Purpose

The purpose of this memo is to document PJM's concerns with Monitoring Analytics' Effective Load Carrying Capability Senior Task Force (ELCCSTF) proposal to remove the performance observations associated with Winter Storm Elliott (WSE), December 22-24, 2022, and Polar Vortex 1 (PV1), January 6-8, 2014, from the resource adequacy risk and accreditation analysis. Removal of these observations significantly reduces overall risk in the model and results in a large shift in risk from the winter to the summer which will substantially change the Forecast Pool Requirement (FPR) and Accredited UCAP (AUCAP) factors. The rationale provided in support of this proposal is the belief that the scheduling actions PJM took during the January 2025 cold weather event will mitigate most, if not all, large-scale correlated outage events in the future. However, a conservative approach to scheduling the system in anticipation of potential, extreme weather events that are forecasted far enough ahead of time, such as was the case in January 2025, is far from a new concept. The advance scheduling steps PJM took in this instance likely had some effect on resource performance as hypothesized later in

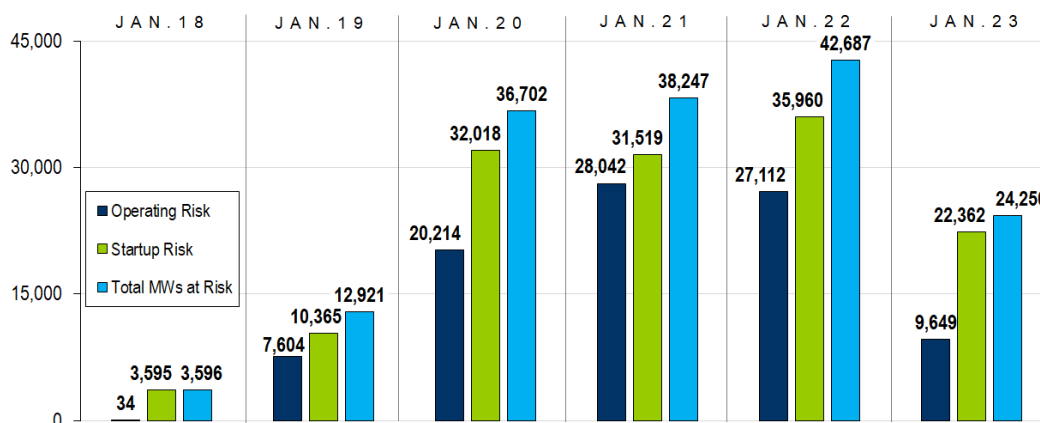
Even with PJM's conservative scheduling in January 2025, the peak forced outage rate during this period reached almost double the annual average.

The average EFORD calculated for the [3rd Incremental Auction for the 2024/2025 Delivery Year](#) was 5.10%. The peak forced outage rate experienced during the January 2025 cold weather event was almost double that at 9.24% as shown on slides 44 and 45 of PJM's [Cold Weather Update to the March 2025 Markets and Reliability Committee](#).

This outage level is higher in total MWs than what was experienced during Winter Storm Gerri in January 2024. During the January 2025 cold weather event, at its highest, there were approximately 17,000 MW of forced outage as compared to about 16,000 MW during Winter Storm Gerri ([see Slide 14](#)).

Generation MWs at Risk During January 2025

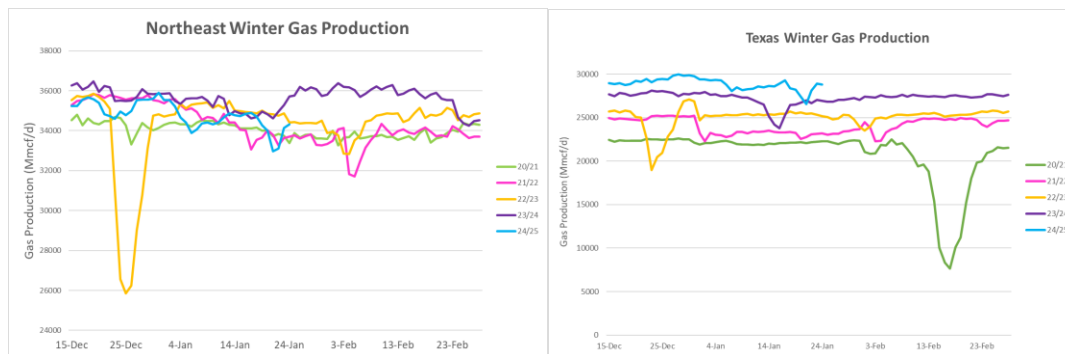
Following WSE and in response to Recommendation 1(f) in the FERC, NERC and Regional Entity Staff Report, "[Inquiry into Bulk Power System Operations December 2022 Winter Storm Elliott](#)", PJM began surveying generation owners for their Cold Weather Operating Limits (CWOL) which were used during the cold weather operations in January 2025. The results of that survey indicate that up to 28,000 MW of generation resources are at risk during their operating cycle (dark blue) is distinguished from startup and fuel-related risks.

As demonstrated by the CWOL report, a significant number of generators have risk of failure when they are already operating. This means they have already purchased fuel and completed the start cycle. This risk of failure falls

outside the bounds of any mitigation step that PJM took in its conservative scheduling in January 2025. It is unclear to PJM how to align this information with the proposal to remove WSE and PV1 performance observations.
